ORIGINATION FORM

Proposed Revisions to a Standard Plans Index
(Please provide all information — Incomplete forms will be returned)

Index Number: 102-602
Sheet Number (s): 1 of 2
Index Title: Two-Lane and Multilane, Work on Shoulder

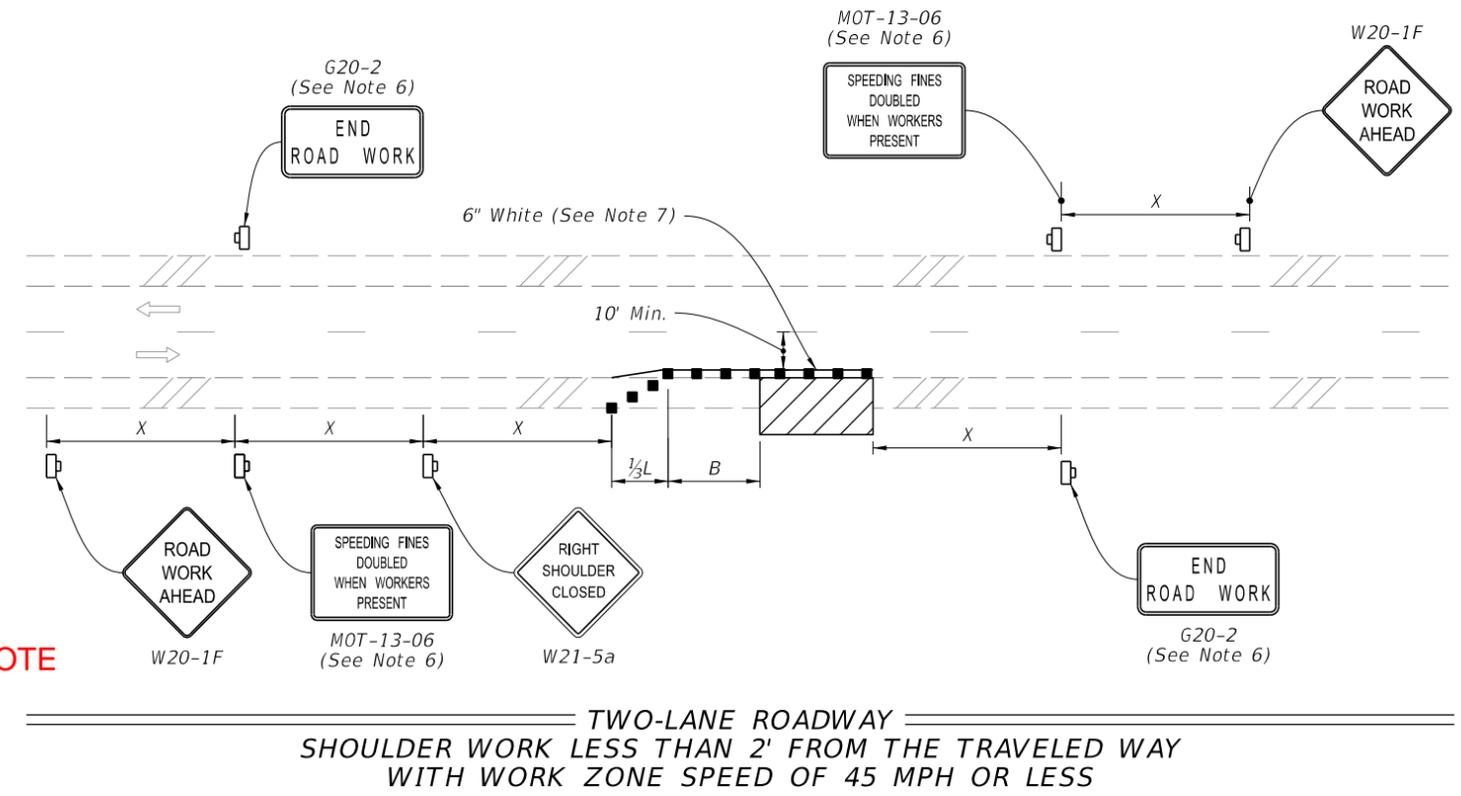
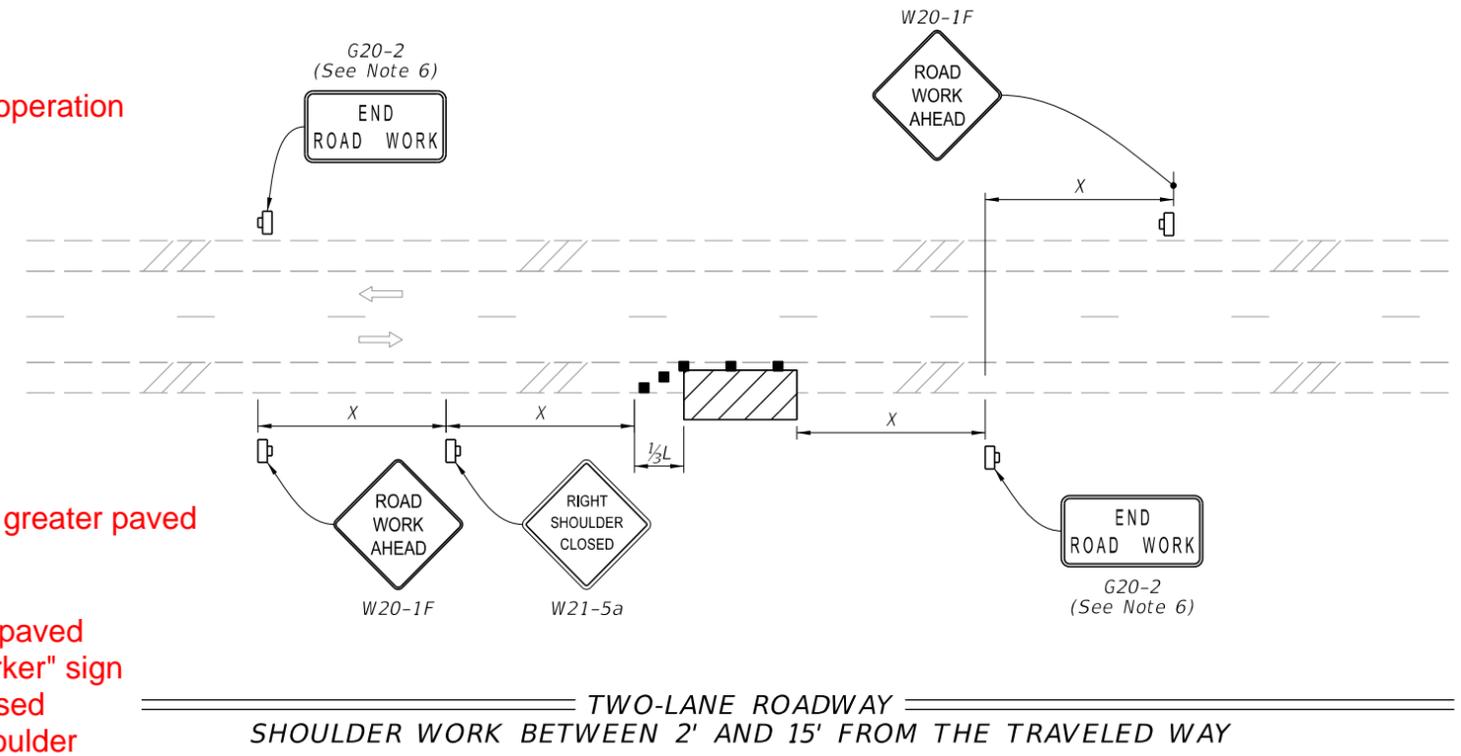
Sheet 1: Updated Note 3 to "Where work activities are between 2' and 15' from the edge of traveled way, the Engineer may omit signs and channelizing devices for work operations 60 minutes or less"; Changed Note 8 - "ridable shoulder" to "4' or greater paved Shoulder"; Added Note 10 "When there is no paved shoulder, the "Workers" sign (W21-1) may be used instead of the "Shoulder Closed" sign (W21-5a)."

The duration provisions of the index are intended to apply to the length time needed to perform the specific temporary traffic control work "operation" shown, which is independent of the duration of an overall construction project. The term "Work Zone" is being replaced with "Work Operation" to clarify the intent.

Wanted to make sure the area discussed was the specific work operation and not the limits of construction. Changed Note 3 to revert back to the previous duration that allowed engineers to omit signs and channelizing devices for work operations 60 minutes or less. changed "ridable shoulder" language to "4' or greater paved shoulder to be clear as to what we mean and not introduce a new term.

ADDED: Note 10
 When there is no paved shoulder, the "Worker" sign (W21-1) may be used instead of the "Shoulder Closed" sign (W21-5a).

UPDATED NOTE

CHANGED TO: work operation

CHANGED TO: operation

CHANGED TO: 4' or greater paved

3. Where work activities are between 2' and 15' from the edge of traveled way, the Engineer may omit signs and channelizing devices for work operations 60 minutes or less.

7. Temporary pavement markings may be omitted when the work operation is in place for 3 days or less.
8. If the work encroaches on a marked bicycle lane or 4' or greater paved shoulder, close the lane or shoulder in accordance with the Plans.

9. Omit "Shoulder Closed" signs (W21-5a) along with associated work zone sign spacing distances for work on the median.
10. When there is no paved shoulder, the "Worker" sign (W21-1) may be used instead of the "Shoulder Closed" sign (W21-5a).
